SUBJECT: Documents addl info discussed during 860807 telcon re
 860116, 0418 & 0627 submittals concerning proposed Tech Spec
 amend to allow use of sleeving method for repair of
 defective steam generator tubes.

Duke Power Company
Oconee Nuclear Station
Documentation of Duke's Response to the
NRC Questions During an August 7, 1986
Conference Call
Steam Generator Tube Sleeving Program

Oscilligrams Limits of the Worst, Intermediate, and
Best Detection Capabilities for the
100%, 40%, and 20% Through-Wall Holes for
0.410" Bobbin Coil Probe

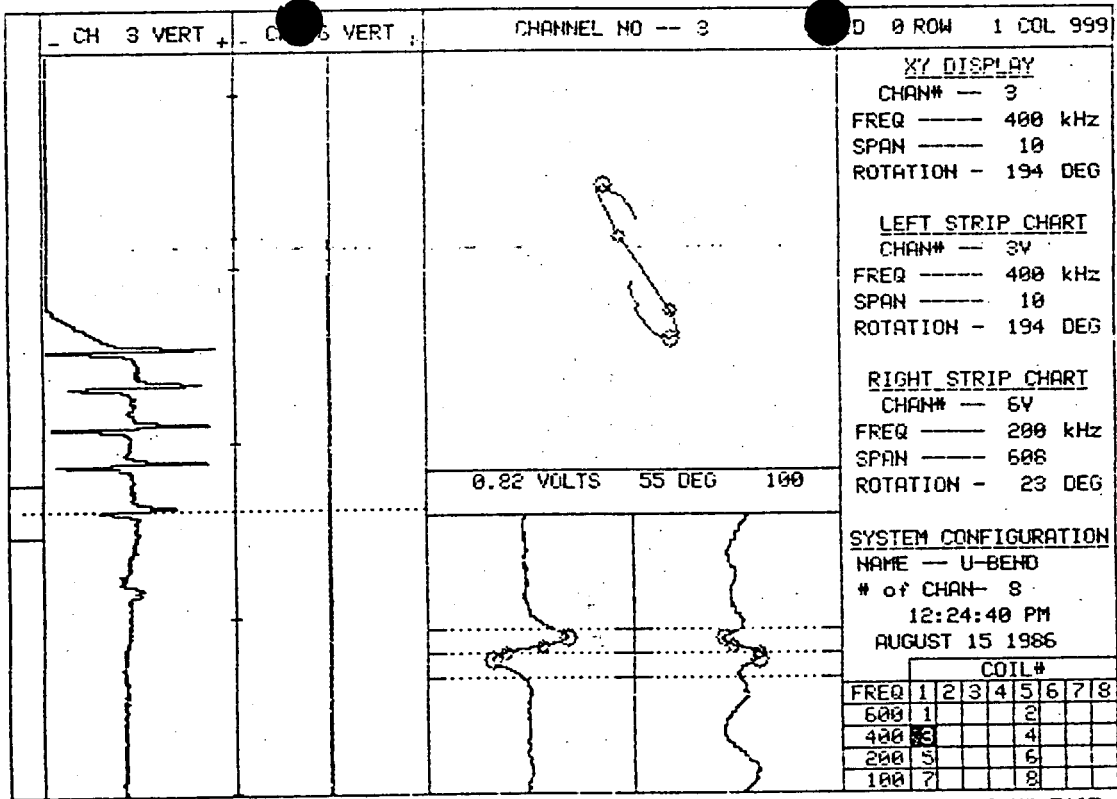
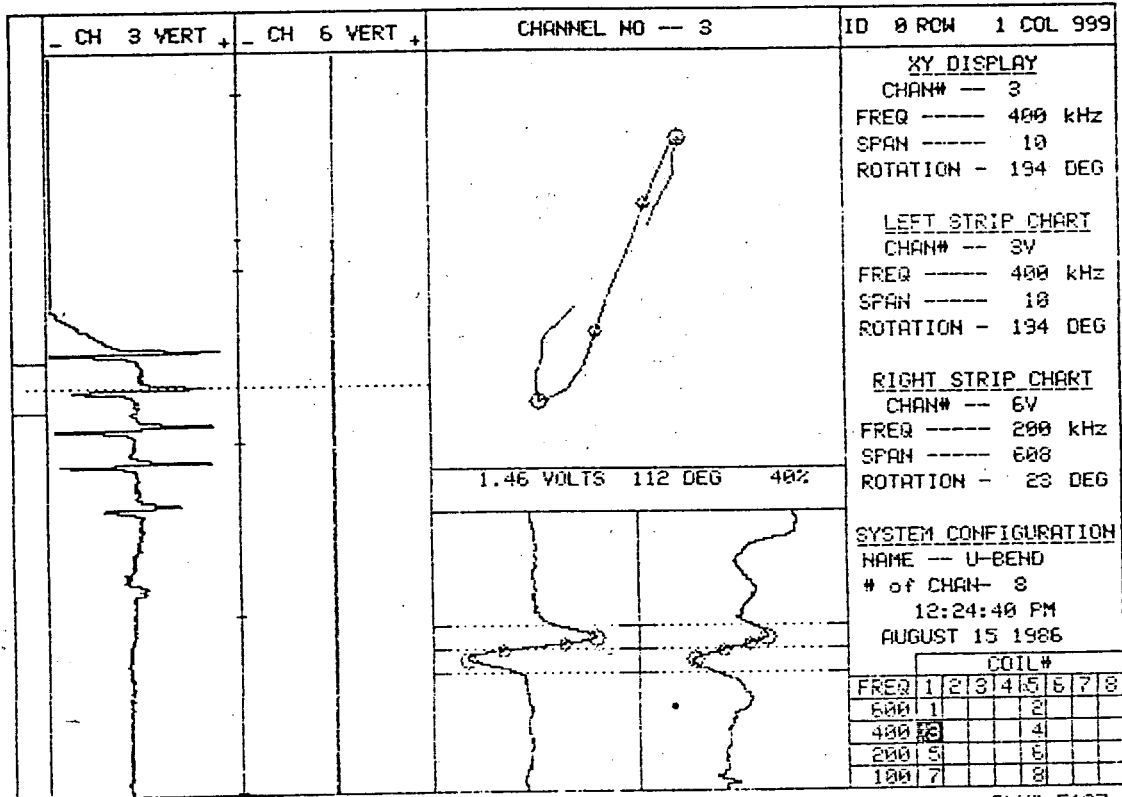
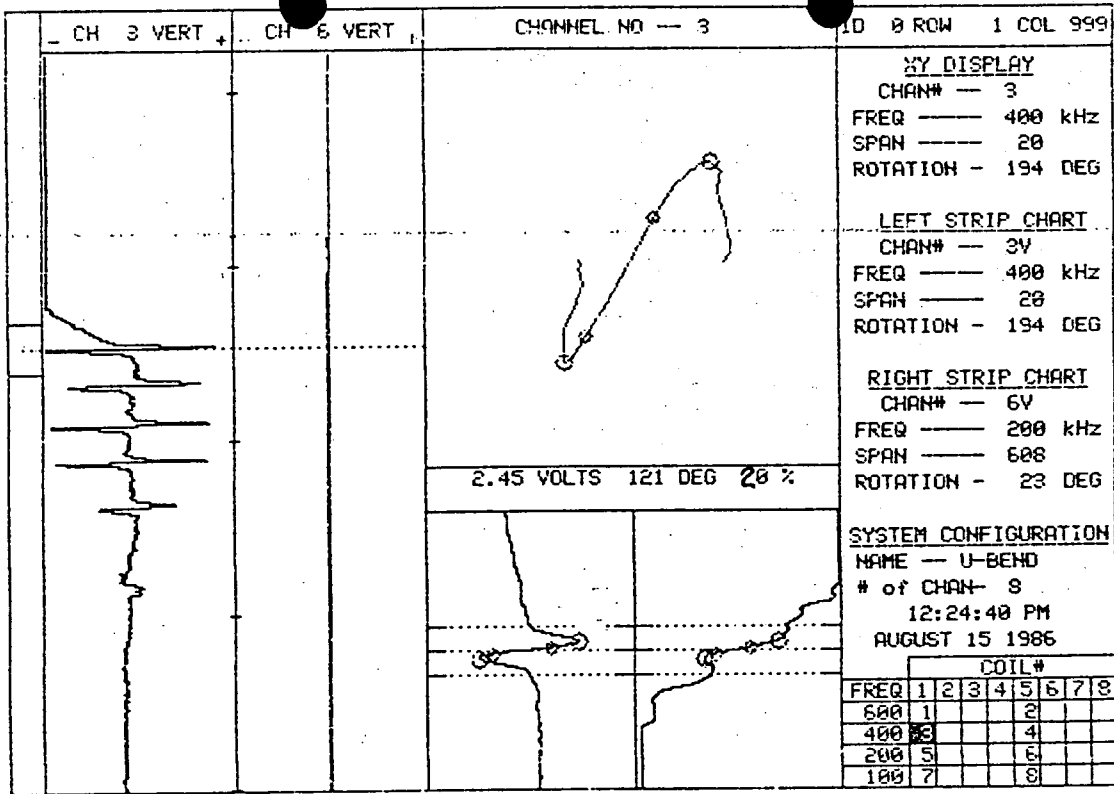
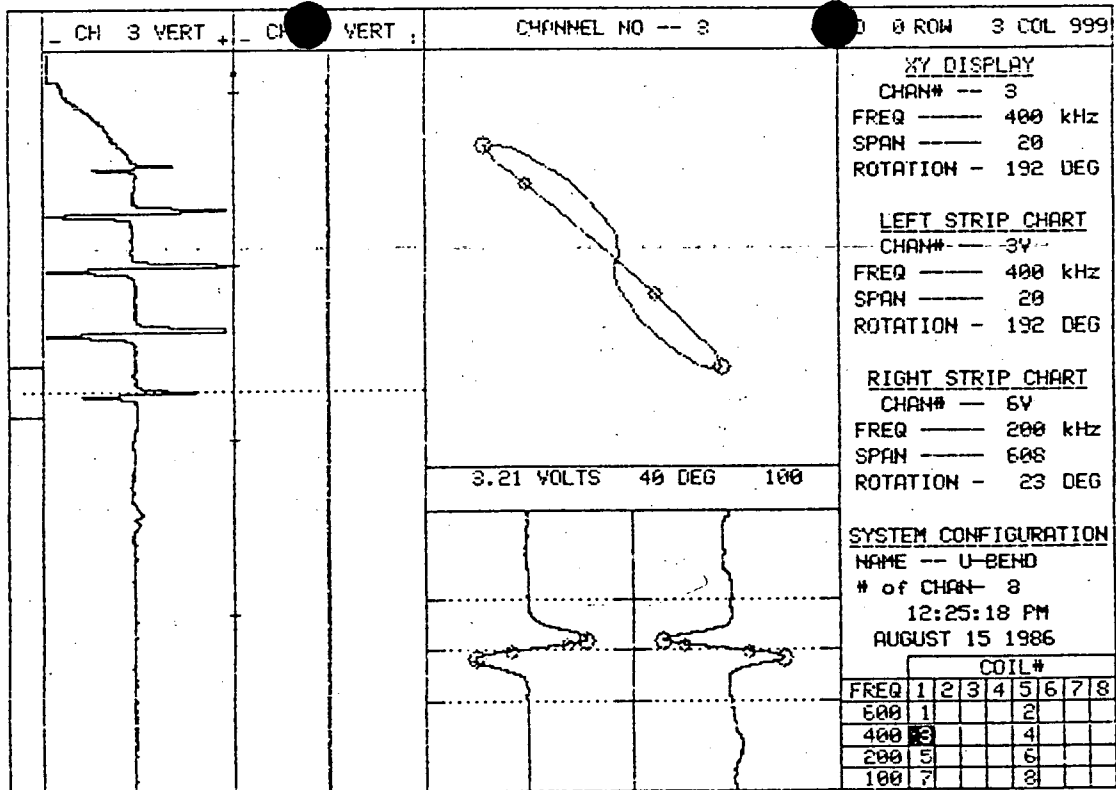
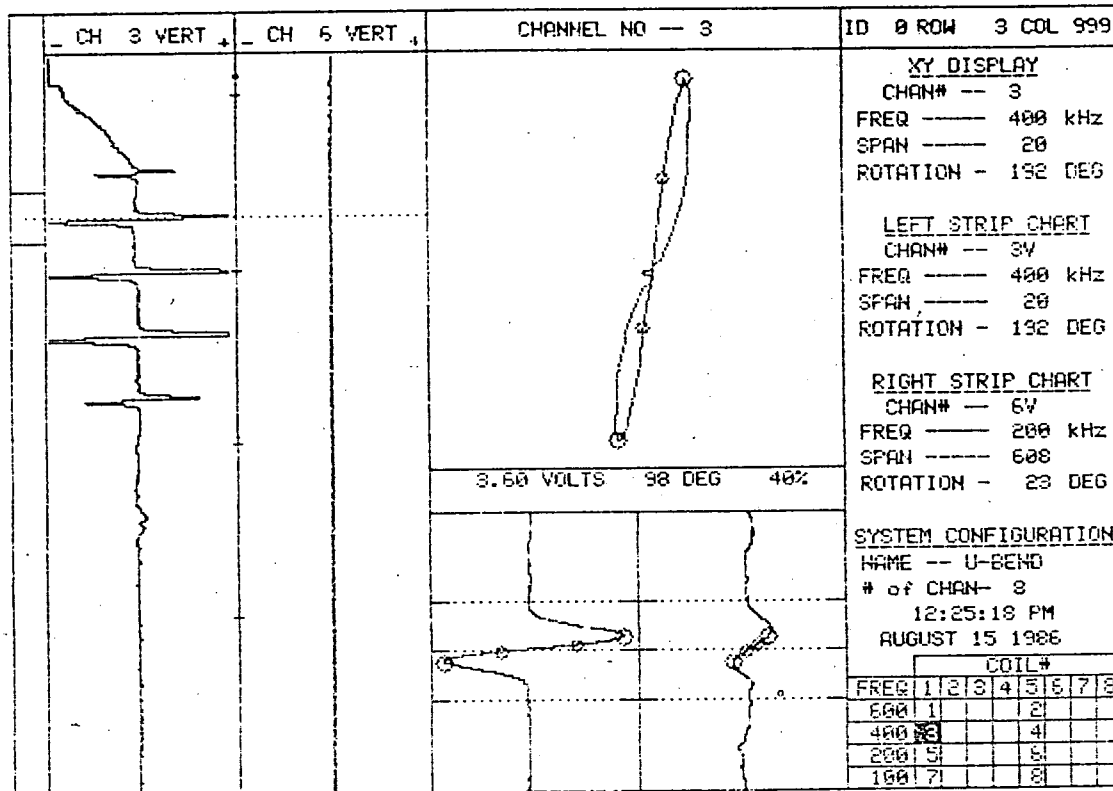
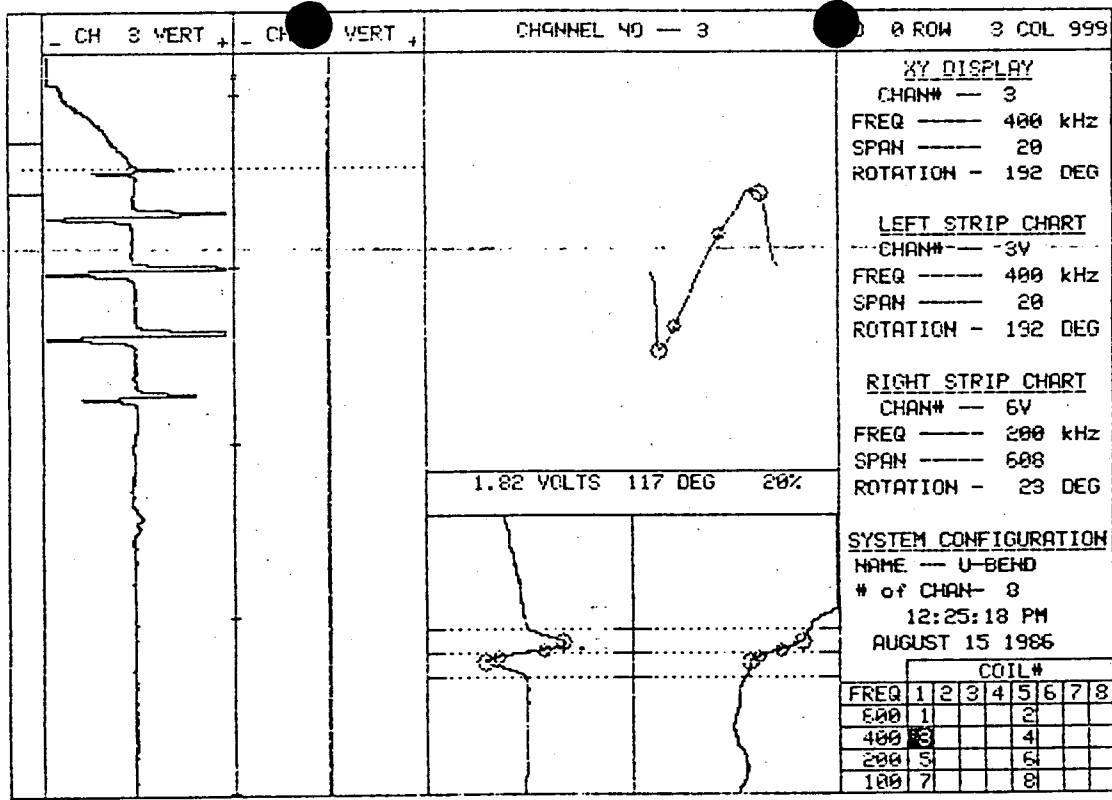
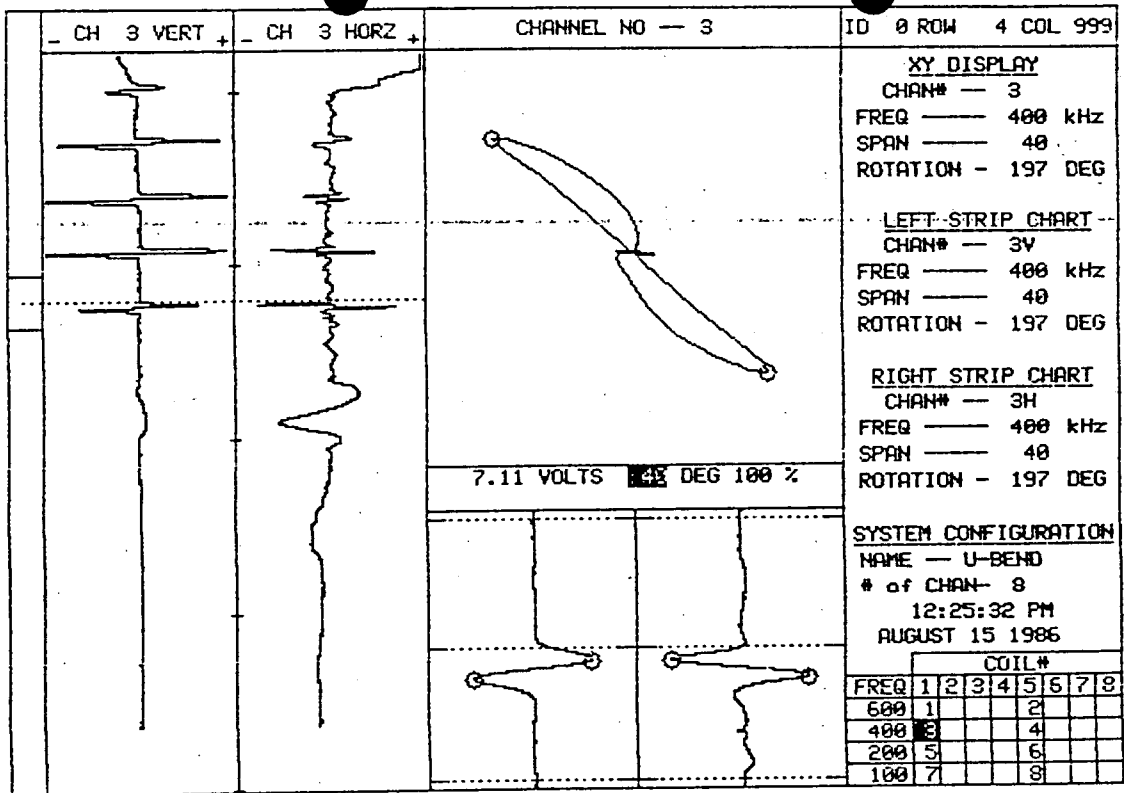
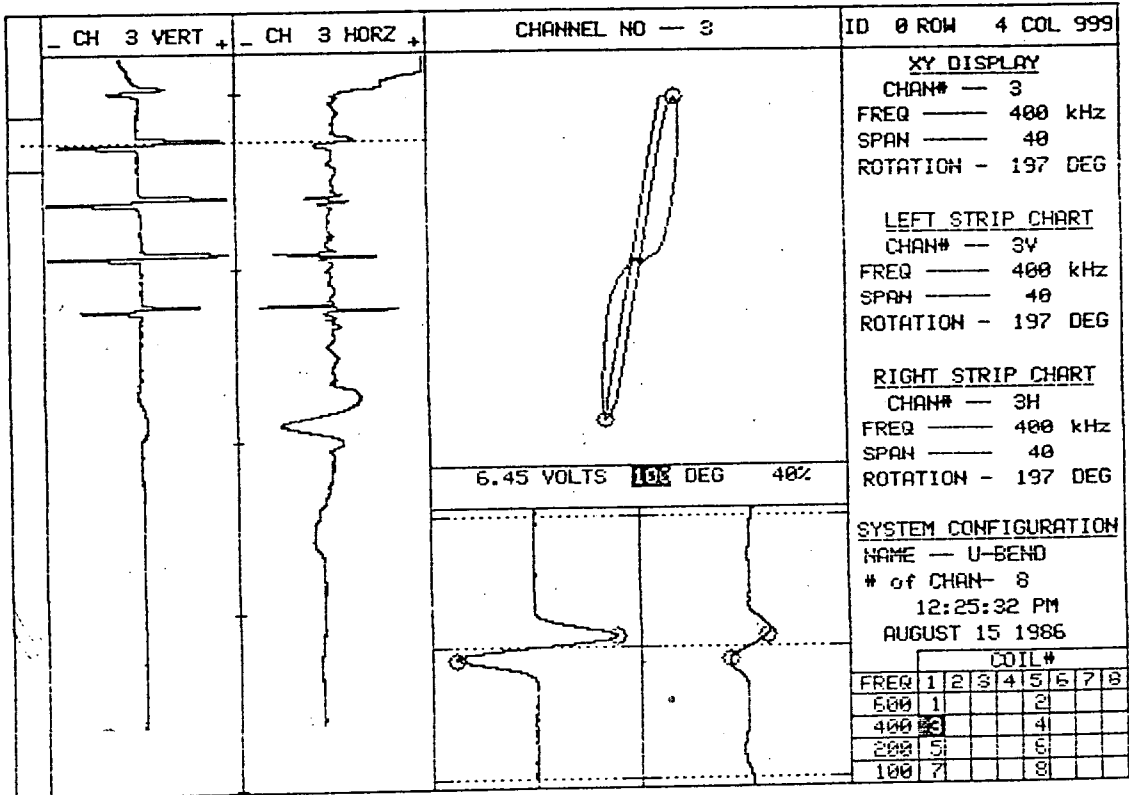
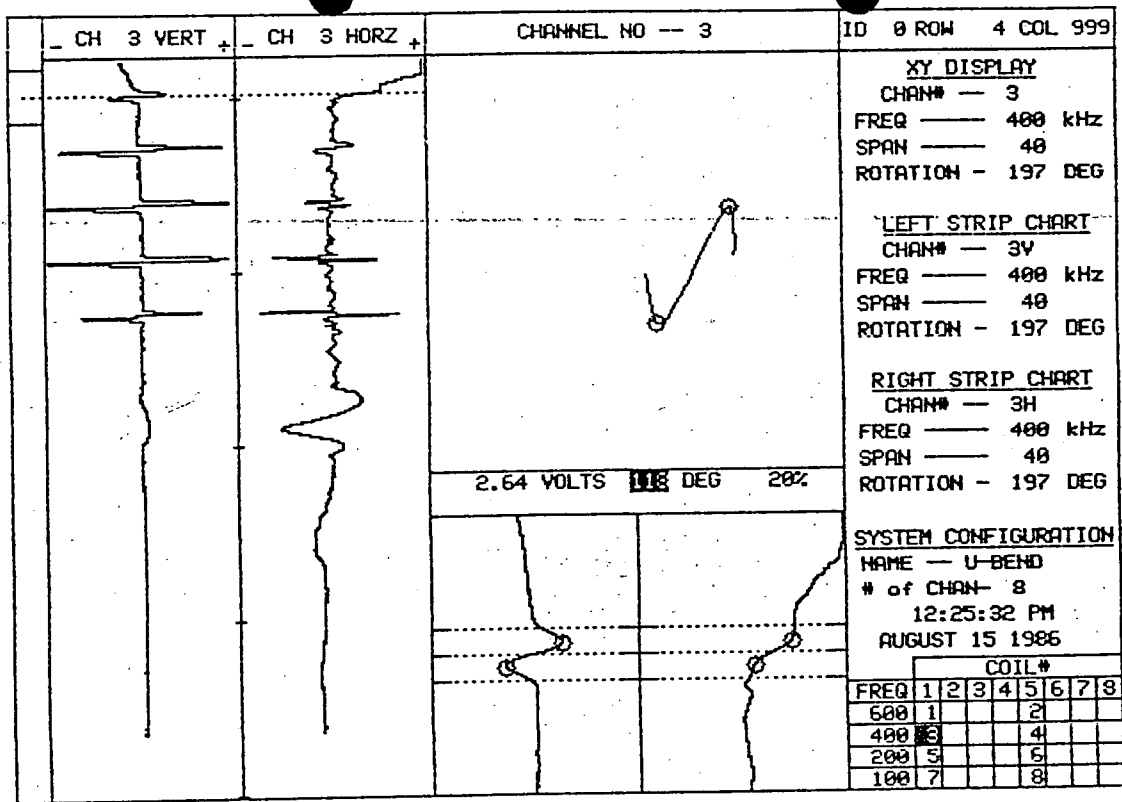
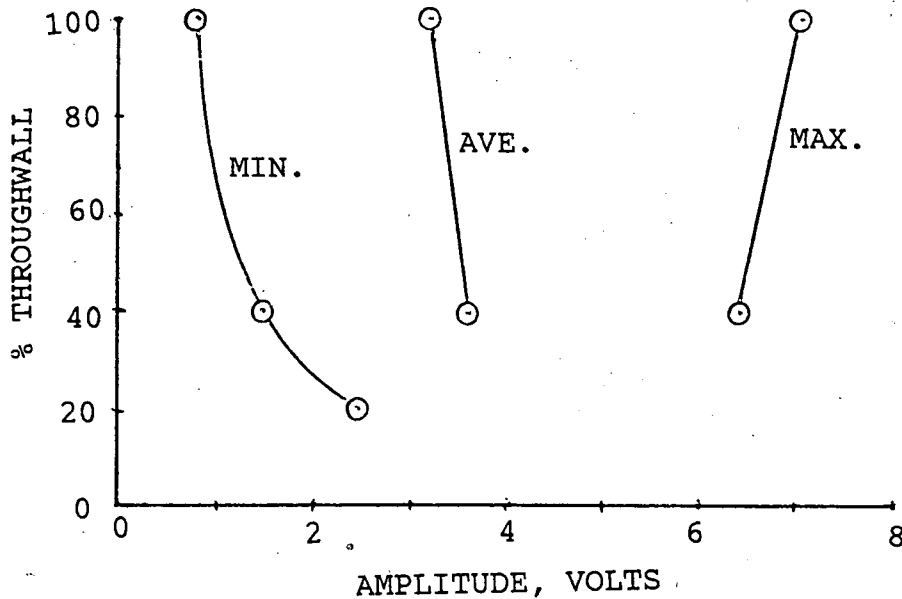
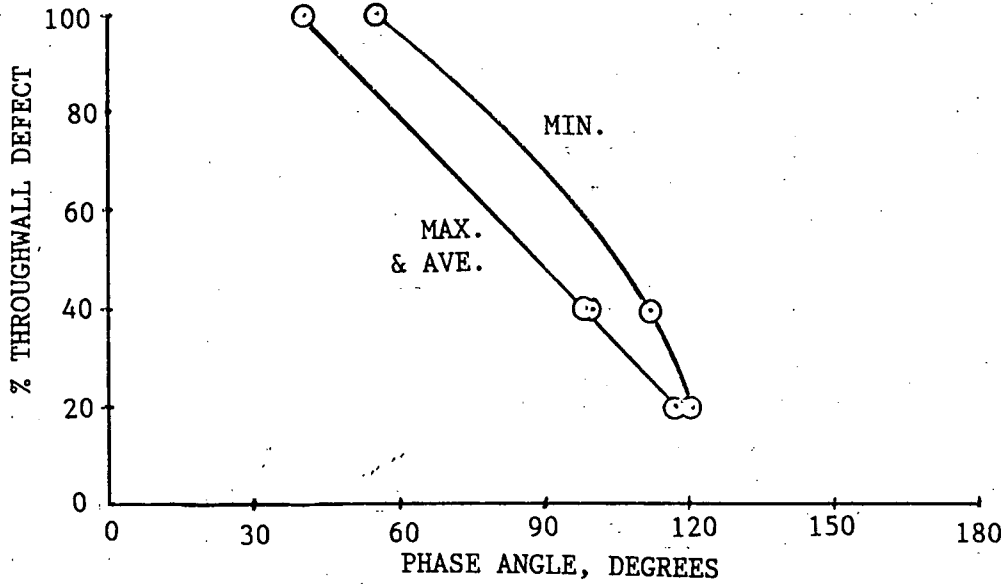
Provide eddy current calibration traces which show the capability to detect actual defects in the OTSG tube with a .410" bobbin coil probe.

For sleeved OTSG tubing, the use of the .410" bobbin coil probe for examining the unsleeved portion of tube has been shown to be acceptable. The .410" bobbin coil is capable of detecting all the flaws in an ASME calibration standard. Attached (Attachment 3) are oscillograms of the worst, intermediate, and best detection capabilities for the 100%, 40%, and 20% through-wall holes. These limits were established by rotating the calibration standard to obtain the minimum to maximum responses of the probe to the flaws. Figures 1 through 3 show the minimum responses that could be obtained by the probe, Figures 4 through 6 represent an average response, and Figures 7 through 9 represent the maximum probe response. The phase angles and amplitudes of these responses are plotted in calibration curves in Figure 10. Once detected, the flaws can be further characterized if required by specialized eddy current techniques, such as inserting a larger coil from the unsleeved end of the tube.
